EASTERN CORRIDOR SEGMENTS II AND III (PID 86462)
**US 50 CORRIDOR FOCUS AREA
ADVISORY COMMITTEE MEETING NOTES**

MEETING #3 NOTES

Sept. 7, 2018

Figure I-13D

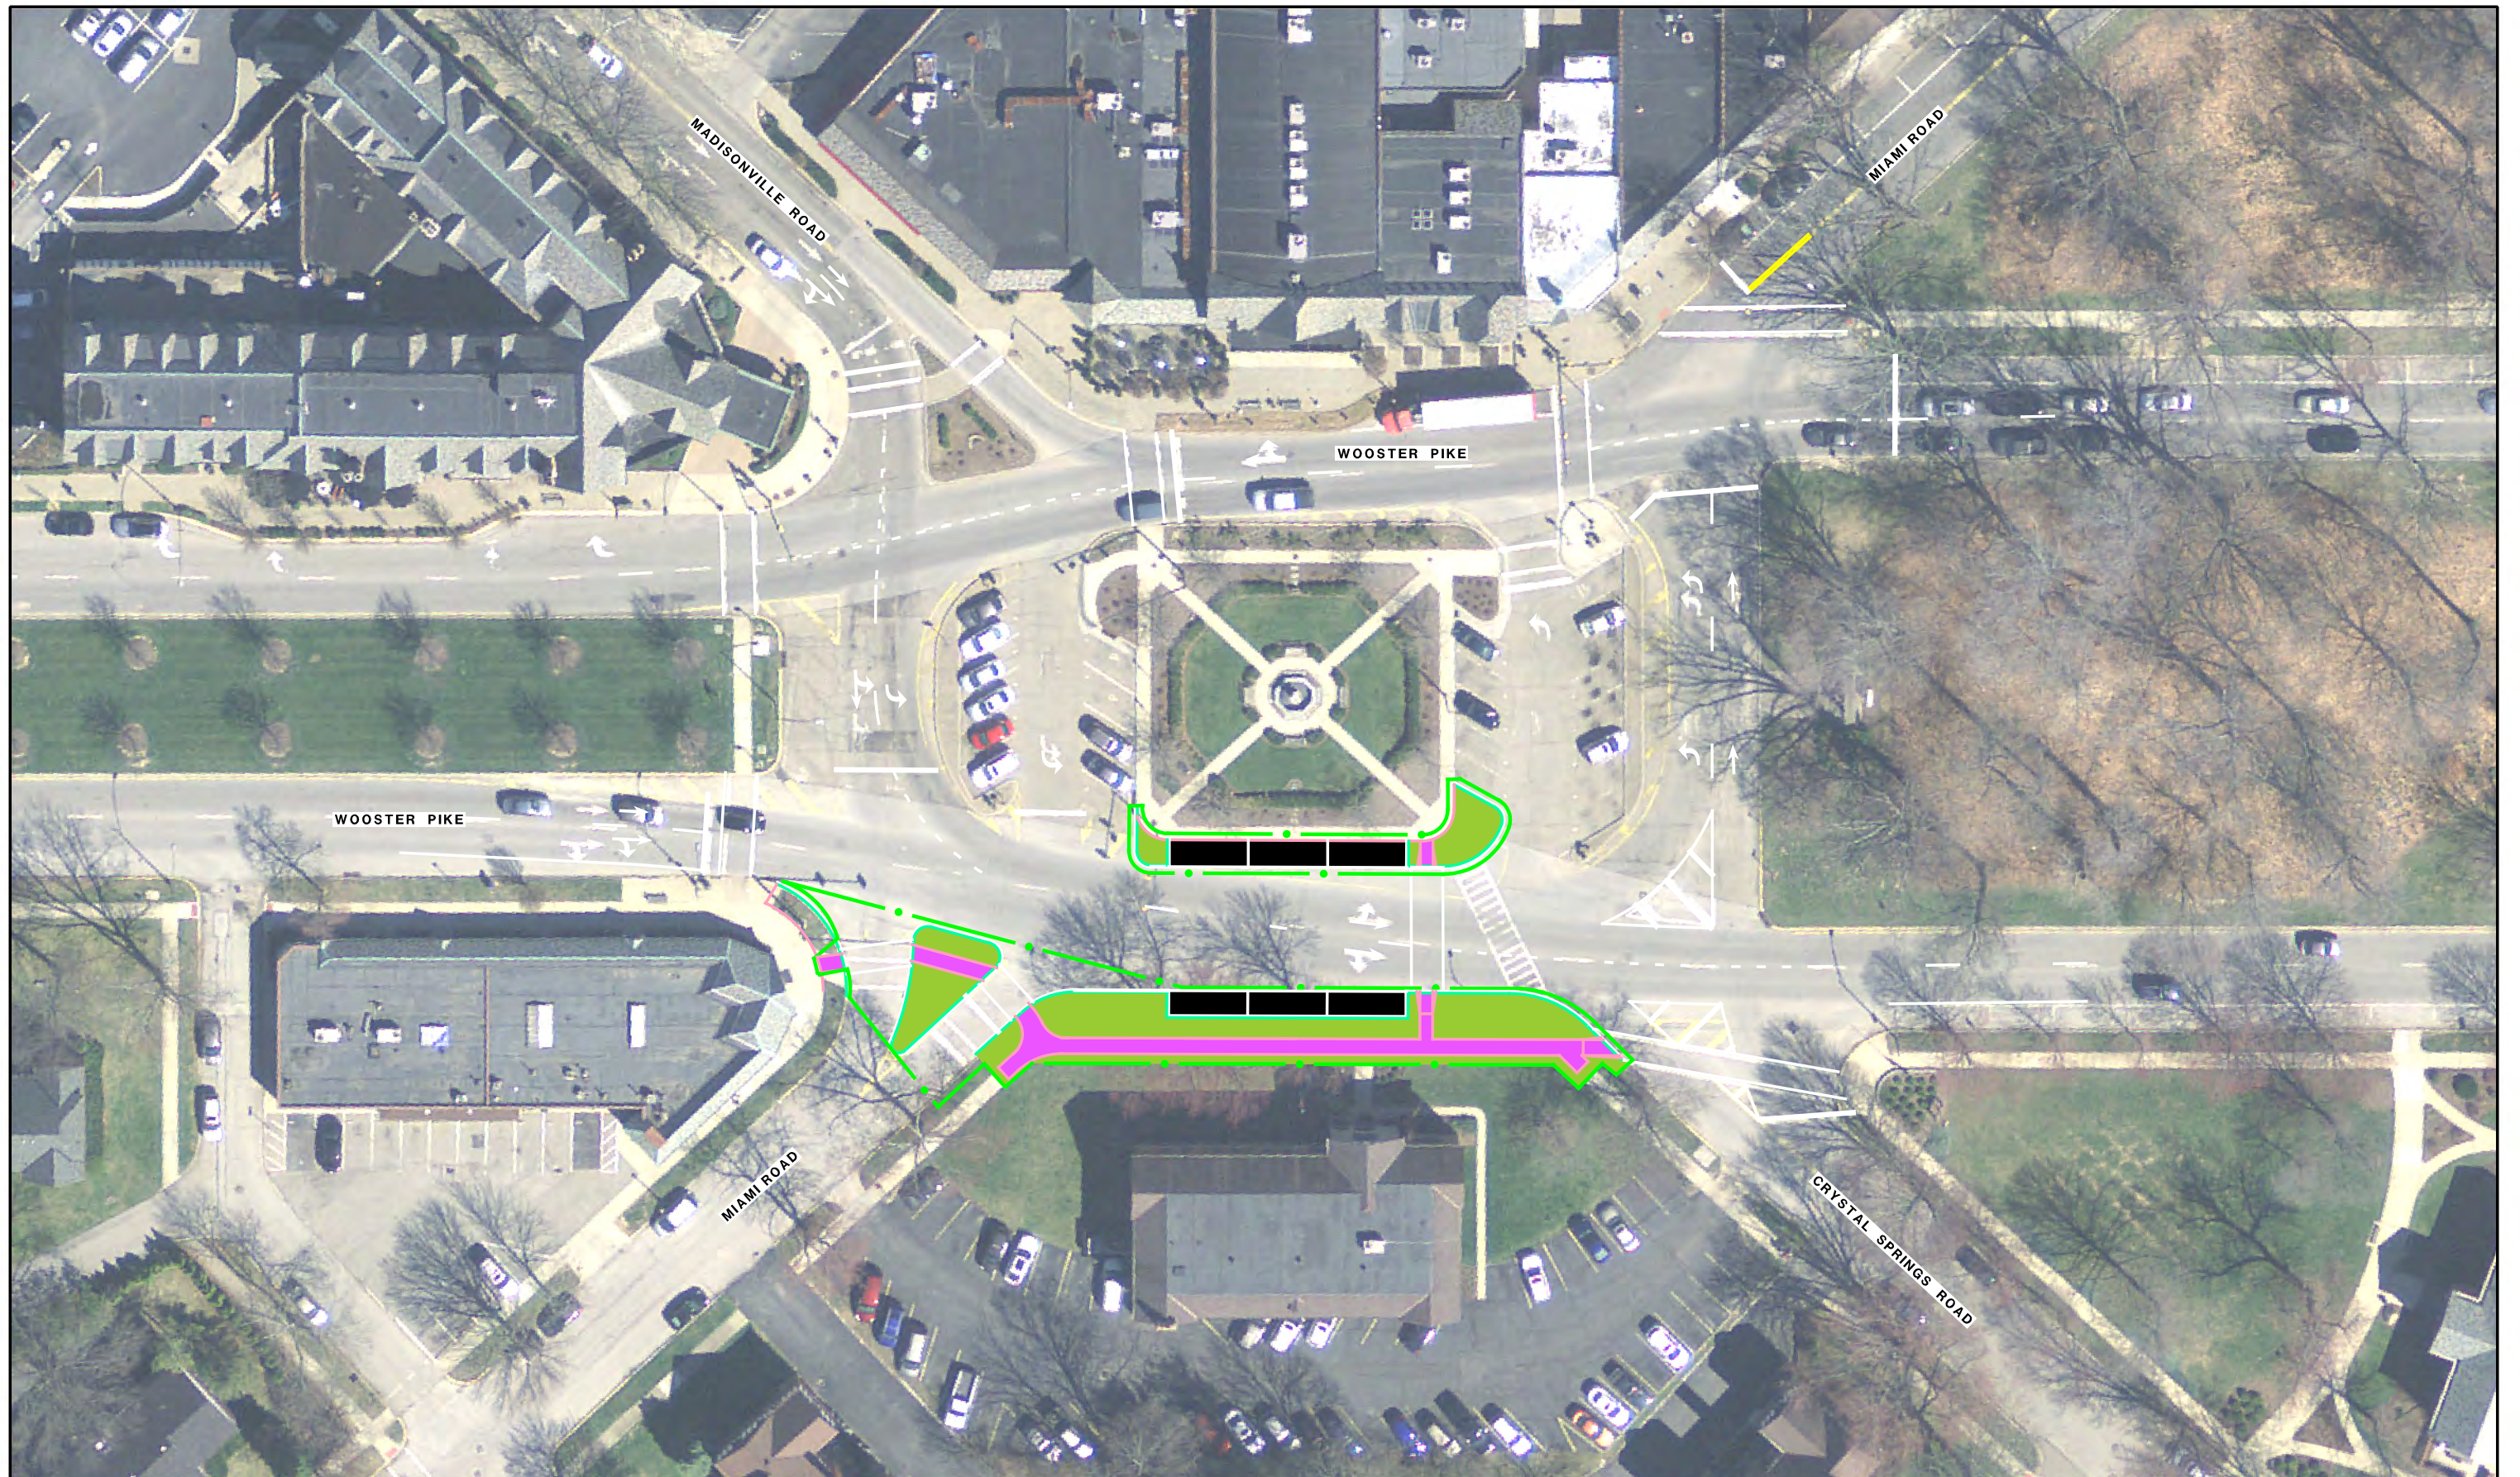
- This concept is intended to address a sight deficiency for drivers traveling northbound on Miami Road and turning right onto Wooster/US 50 (south side of Mariemont Square). This movement is currently not signalized.
- A curb bump would be added, moving the stop bar (line in the road) forward so that drivers are better able to see past the existing building on their right.
- The concept has the additional potential benefit of straightening the existing crosswalk. This would be particularly helpful for pedestrians.
- The four existing parking spaces would be preserved.
- Pavement removed in this concept could be replaced with grass. Existing trees would be saved.
- A new raised island could be established on Miami Road, similar to the island on Plainfield Road on the north side of the Square

- Mariemont will provide sketch outlining design options. Limited time being allowed to submit comments did not allow Mariemont to submit sketch at this time. Continued dialogue is needed to address safety, parking, and aesthetics.

- The only difference between this option and Concept I-13e is whether to retain the three, parallel parking spaces along the south side of the center island in Mariemont Square. In this alternative, the parking spaces are retained.
 - There are aesthetic benefits to removing the parking spaces; however, they are often used by patrons of businesses in Mariemont Square.
- One parking space would be removed on the south side of the US 50/Wooster Pike in the Square, in front of the businesses. Removal of this space improves sight lines for vehicles on Crystal Springs Road and therefore improves travel safety.

- Advance for public consideration.

Figure I-13E

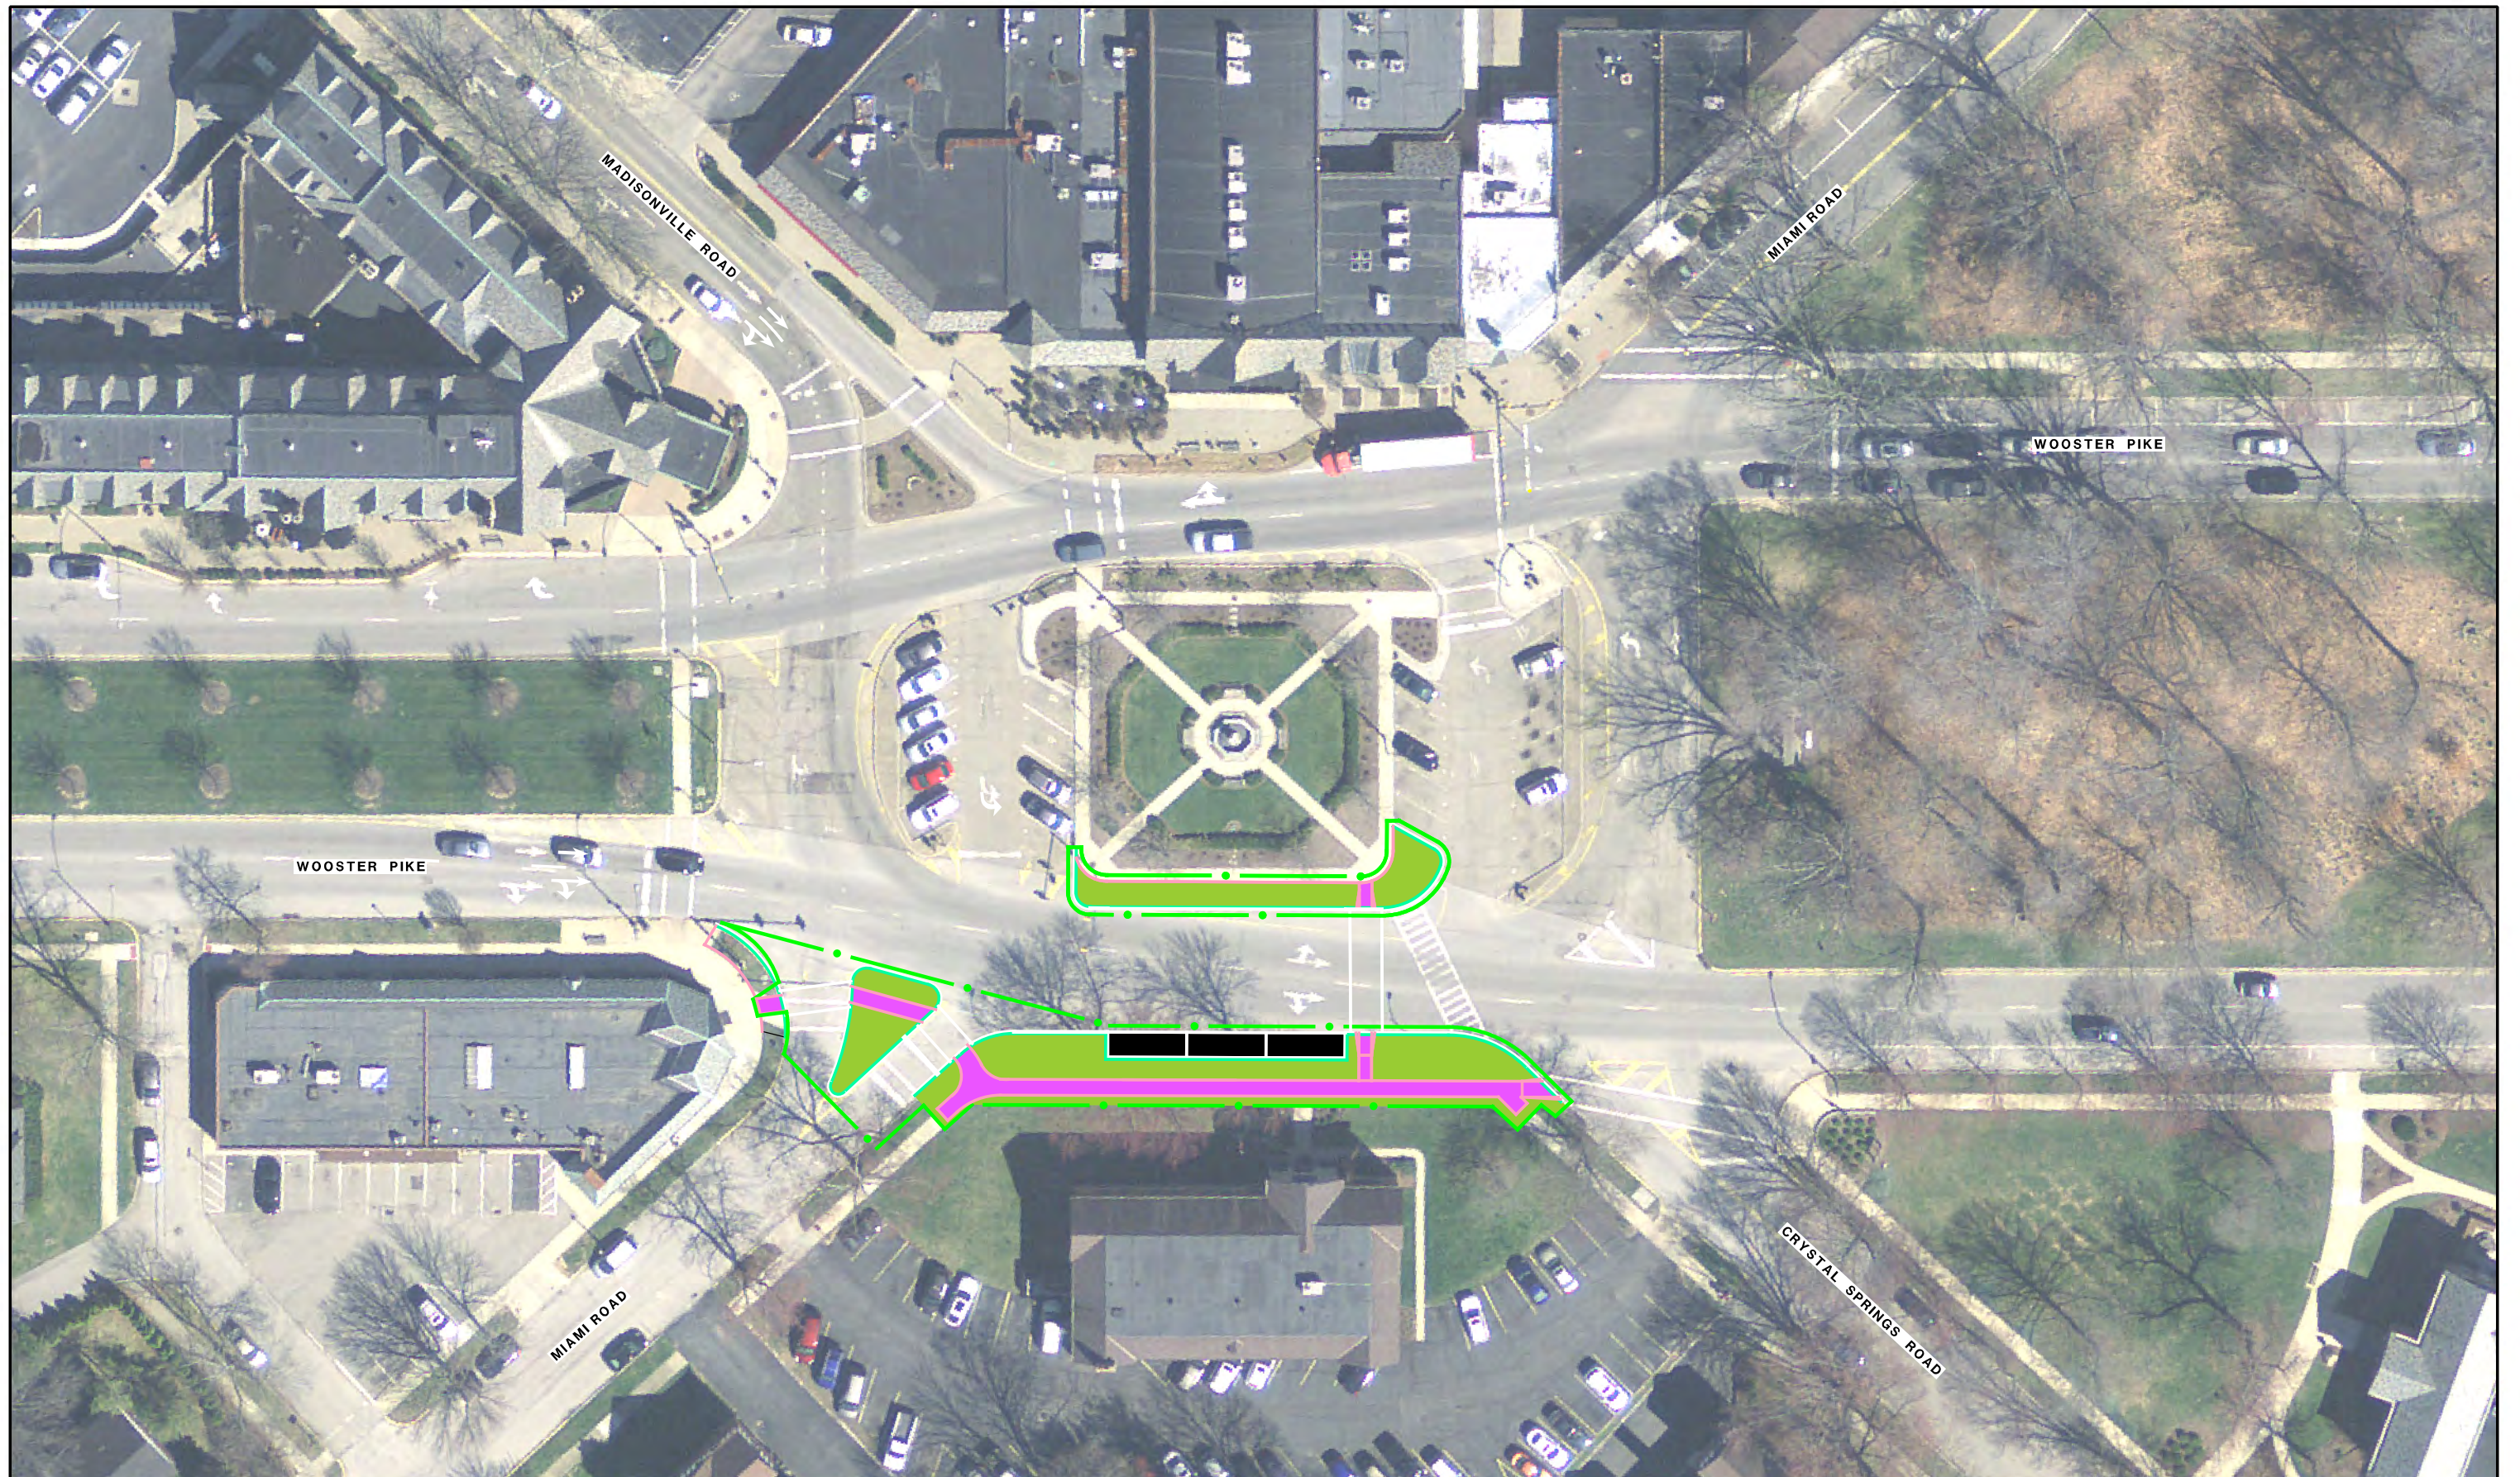
- This concept is intended to shorten the length of the crosswalk across US 50 at Crystal Springs Road at the southeast corner of the Square.
- Bump outs on both sides of US 50 would not impede traffic lanes but would shorten the amount of time pedestrians spend in an uncontrolled crossing.
- The two eastern-most parking spots on the south side of the Square would be removed to improve sight distance.
- This concept could be implemented in conjunction with I-13d.
- The committee suggested the following:
 - Consider adding a straight crosswalk on the southeast corner of the Square to connect the two shortest points.
 - Consider installing blinking lights on crosswalks to help improve their visibility (ODOT noted that Mariemont would need to fund the addition of blinking lights)

- Mariemont will provide sketch outlining design options. Limited time being allowed to submit comments did not allow Mariemont to submit sketch at this time. Continued dialogue is needed to address safety, parking, and aesthetics.

- The only difference between this option and Concept I-13d is whether to retain the three, parallel parking spaces along the south side of the center island in Mariemont Square. In this alternative, the parking spaces are removed.
 - There are aesthetic benefits to removing the parking spaces; however, they are often used by patrons of businesses in Mariemont Square.
- One parking space would be removed on the south side of the US 50/Wooster Pike in the Square, in front of the businesses. Removal of this space improves sight lines for vehicles on Crystal Springs Road and therefore improves travel safety.

- Advance for public consideration.
